**HUDSON RIVER PCBs REASSESSMENT RI/FS
RESPONSE TO PEER REVIEW COMMENTS ON THE
DATA EVALUATION AND INTERPRETATION REPORT (DEIR) AND
THE LOW RESOLUTION SEDIMENT CORING REPORT (LRC)**

NOVEMBER 2000

**U.S. Environmental Protection Agency
Region II
and
U.S. Army Corps of Engineers
Kansas City District**

**TAMS Consultants, Inc.
TetraTech, Inc.**

Figure 5-1
Water Column Total PCB Annual Load at Fort Edward, TI Dam, and Schuylerville from GE Data
(Ratio Estimator)

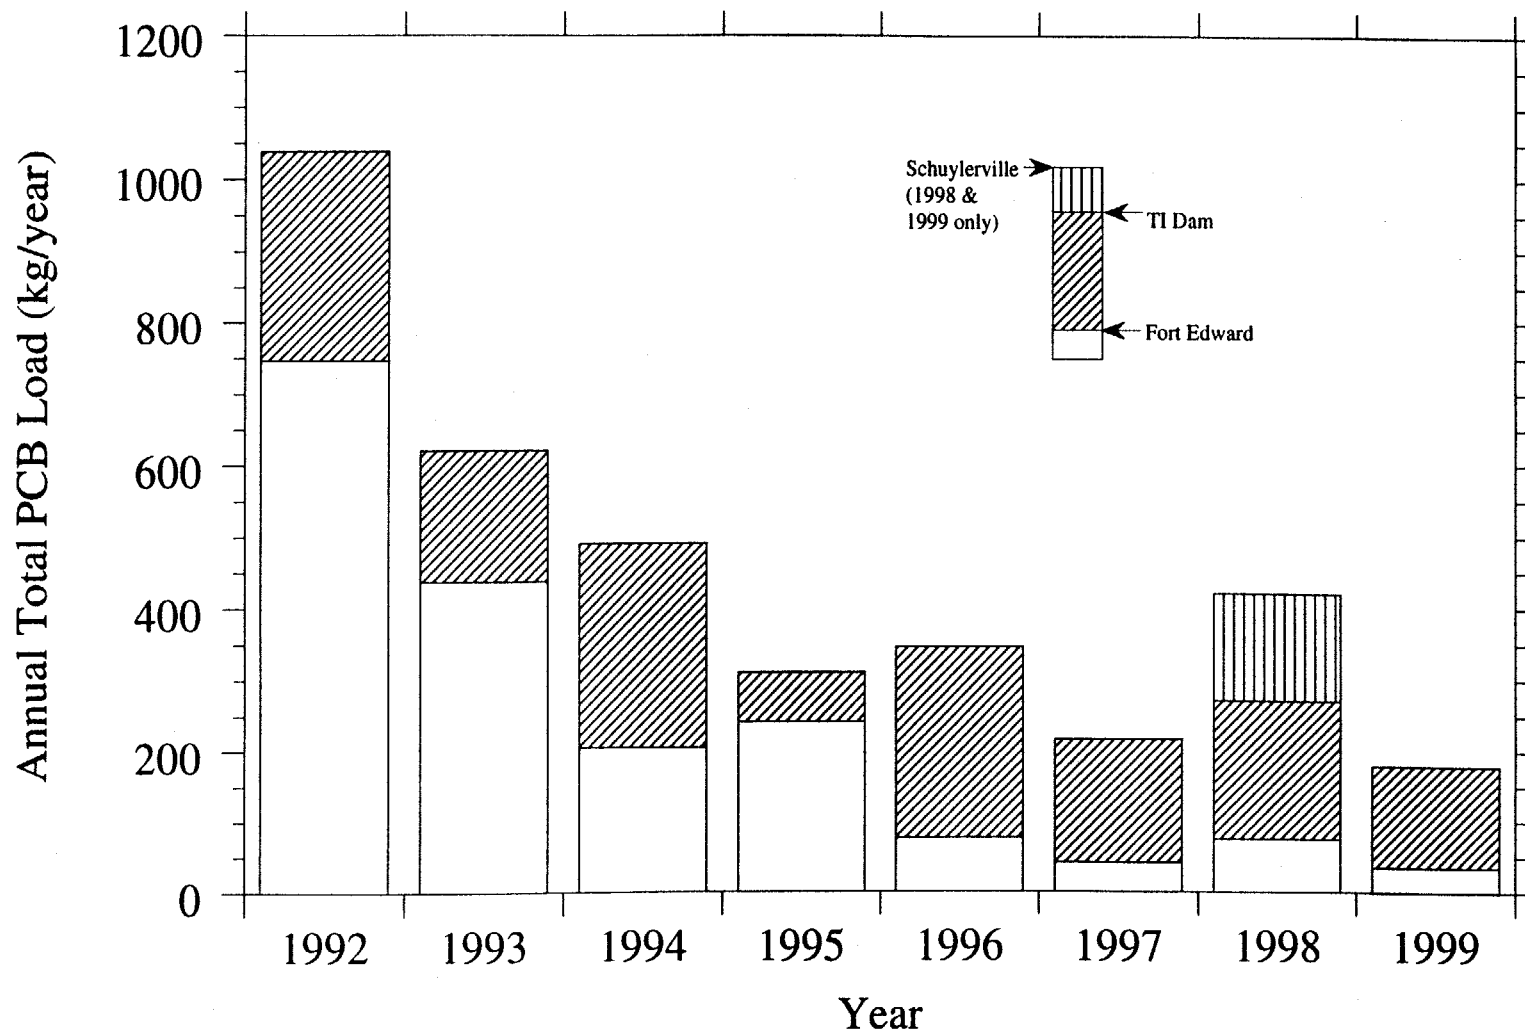
Comment 5: Validate conceptual models and other findings with more recent water column sampling data.

Response 5: Since the completion of the Phase 2 sampling efforts, there have been no similar intensive surveys of the Upper Hudson to directly extend the Phase 2 results. However, as was done in the DEIR, other data sets have been utilized so as to extend and confirm the DEIR findings. To this end GE and USGS data were examined up to 1996 in estimating water column concentrations. The Revised Baseline Modeling Report continued this analysis by including data up to 1997 in its calibrations and utilized more recent data (from 1998 and 1999) as part of model verification. USEPA will continue to review new data as it becomes available, as appropriate. Additionally, the modeling analysis for the Reassessment also serves to examine and validate the conceptual models applied in the DEIR and LRC.

In response to this comment, more recent data obtained by GE on water column concentrations at Rogers Island, Thompson Island Dam and Schuylerville were reviewed. These results were examined for the purposes of examining the incremental load increases between these stations to see if the TI Pool sediments continue to release substantial amounts of PCBs. Water column total PCB annual loads were calculated based on GE weekly water samples and USGS flow data at Rogers Island, TI Dam and Schuylerville using a ratio estimator method (USEPA, 1997). Loads at the TI Dam were corrected to estimate center channel conditions based on the contamination and flow conditions at Rogers Island as mentioned in the Responsiveness Summary for Low Resolution Sediment Coring Report (USEPA, 1999d).

In the conceptual model of the Upper Hudson, TI Pool sediments and, to a lesser degree, sediments between TI Dam and Schuylerville, contribute substantial amounts of PCBs to the water column during the warmer months of the year. Thus, if this is true, then water column load should increase substantially relative to Rogers Island each year. This has already been examined to a degree by GE and its consultants (QEA, 1998). The evaluation below, serves to update the QEA analysis. Figure 5-1 compares the water column load for the three stations. Clearly evident in the most current data available is the substantial load gain between Rogers Island and TI Dam. A smaller load gain

Figure A-1
Congener Loadings for Principal Components 1 and 2
 (51 congeners, All HR Cores and Water Column Data from RI, TI Dam, and Schuylerville)

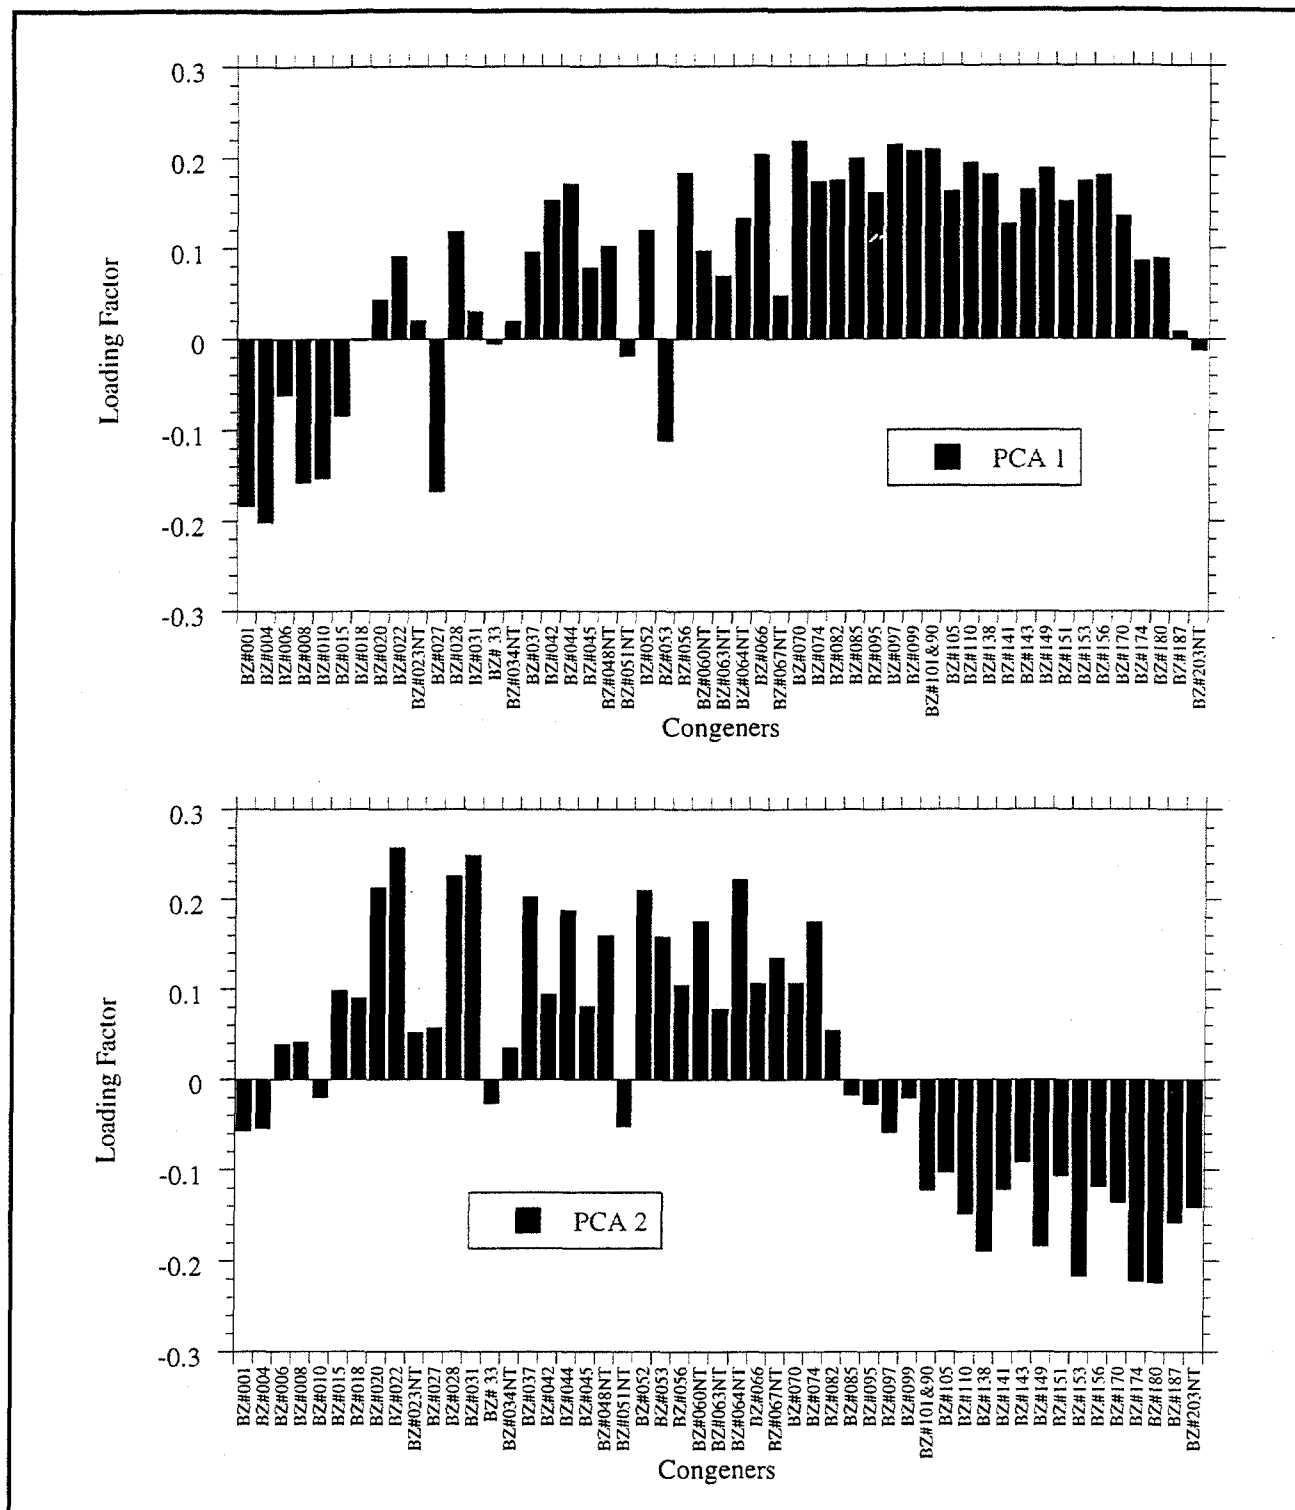
Comment 1: Use multivariate statistical analyses of the data to support the conclusions of the DEIR and LRC.

Examination of the Congener Composition of the First Two Principal Components: The PCA results for the selected samples and 51 congeners yielded two principal components whose properties were readily interpretable from a geochemical perspective and directly supported the bivariate analyses presented in the DEIR. Figure A-1 presents the congener loadings for the first two principal components. Principal component 1 is represented in the uppermost diagram and can be described as the ratio of the dechlorination product congeners BZ# 1, 4, 6, 8, 10 and 27 to the remaining congeners in the sample. Notably, congeners 6 and 27 are included in this grouping. These congeners, like BZ#8, represent intermediate dechlorination products since subsequent dechlorination will reduce each of these congeners to BZ#1. Congener BZ#15 is also associated with this group and may represent the dechlorination result of congeners without ortho-chlorines. Congener BZ#53 is also associated with this group and may represent a dechlorination intermediate as well. BZ#19, another dechlorination product congener was screened out by the selection criteria

The second principal component is shown in the lower diagram of Figure A-1. This component represents the ratio of the lower molecular weight congeners (mono to tetrachlorohomologues) to the higher molecular weight congeners (penta to nonachlorohomologues). This division occurs essentially at the tetra-penta homologue boundary, since BZ#82 represents the first pentachlorohomologue in the set of congeners. This component is related to the molecular weight of the PCB mixture and is essentially a measure of the Aroclor 1242 components to the sum of the Aroclor 1254 and 1260 components. This can be seen by comparing the loadings for component 2 against the mass fractions for Aroclors 1242, 1254 and 1260 (see Figure A-2).

Figure C-3
Comparison of Absolute Congener Load Difference Between Schuylerville and Waterford
Transect 6, August 1993

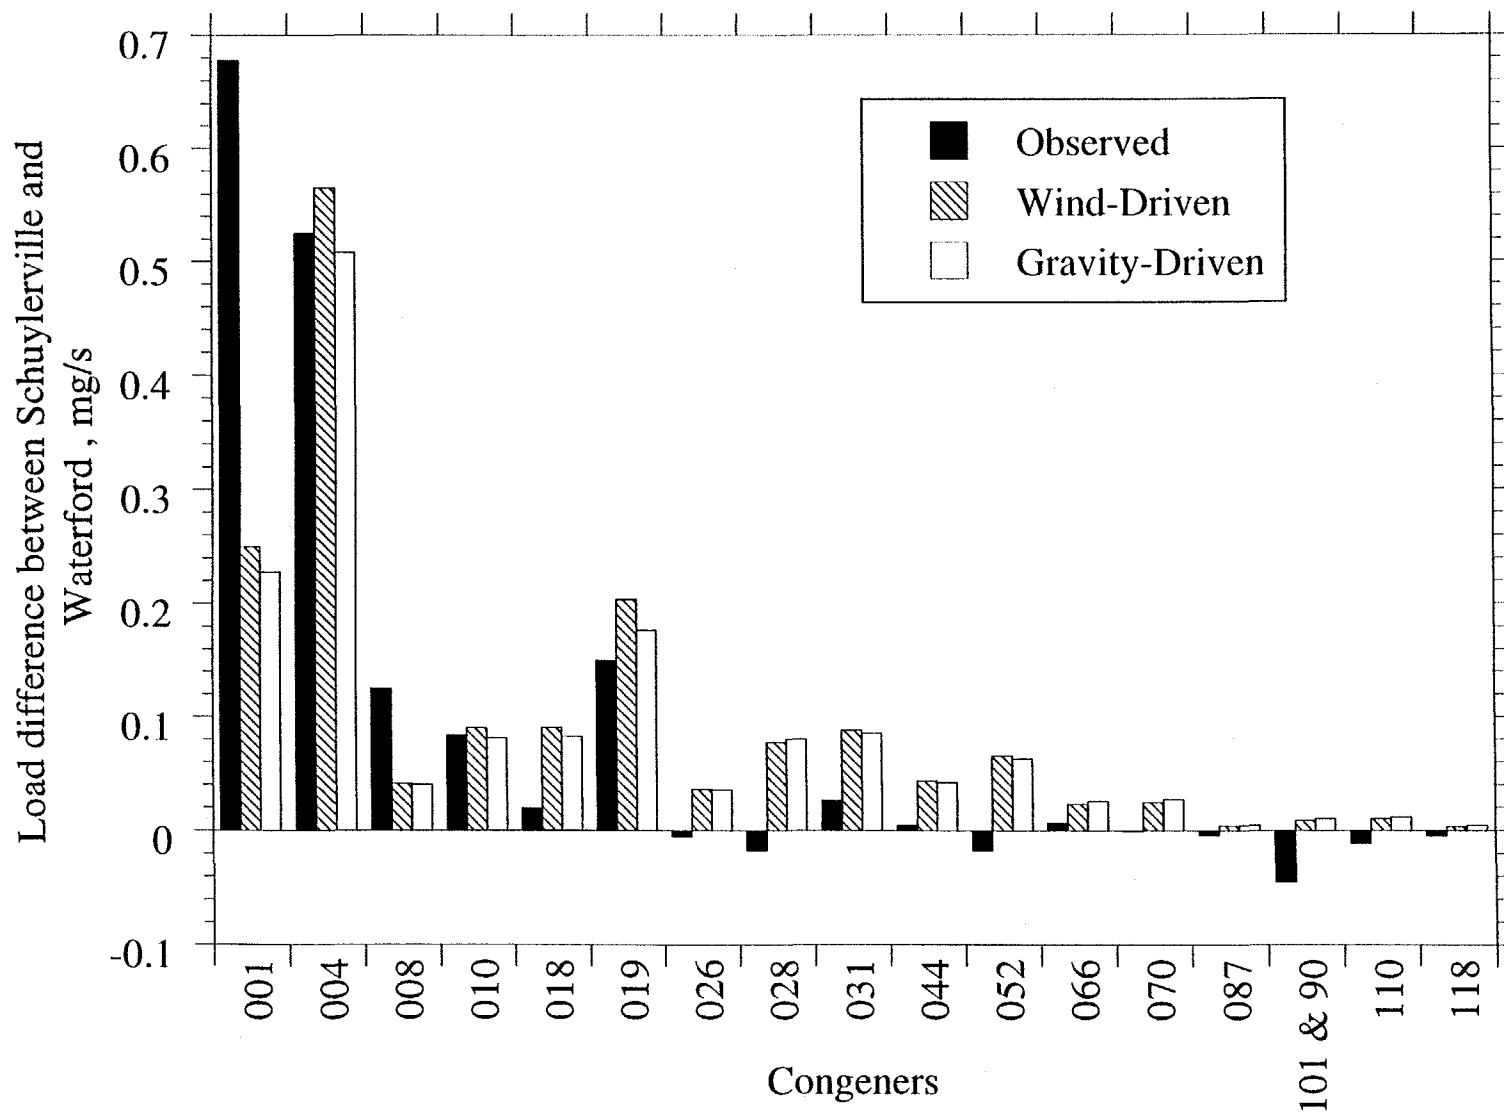
Comment 13: Consider other compartments in the PCB mass balance (e.g., evaporative losses, photo chemical degradation, aerobic degradation).

In addition to the model analysis, USEPA has also estimated the gas exchange rate for several of the transect events where detailed information on flow, PCB concentration, and other conditions are well-known for the transect period. The results of these calculations are discussed in Attachment C of this Response to Peer Review Comments. The basic finding of these calculations is that the observed patterns of PCB loss from the water column are not a close match to those expected from gas exchange. Additionally, the scale of congener losses from the water column estimated from gas exchange are of the same magnitude as the observed losses but the gas exchange estimates are consistently higher than the observations. The implications of these findings are to suggest the possibility of other mechanisms of PCB loss from the water column, such degradation, while also signaling the addition of PCBs to the water column from the sediments below Schuylerville. The magnitude of these additions is clearly smaller than the loads originating upstream of Schuylerville and TI Dam.

The results were also examined on a relative basis, normalizing to the total load at Schuylerville so that values represent the percentage of the load at Schuylerville that was lost or gained while traveling to Waterford. These results are shown in Figures C-4 and C-5 for the two transects. These diagrams provide a better perspective of the effect of gas exchange on the individual congeners. In transect 5 (Figure C-4), the model estimates fall substantially short for BZ#1 and BZ#8 as well as for BZ#66 and higher, as noted above. However, expressed in this fashion, the results illustrate that fairly large portions of the total water column loads for the individual congeners are lost to gas exchange between Schuylerville and Waterford. This is especially true for the lighter congeners where losses were calculated to be on the scale of 40 percent of the total inventory.
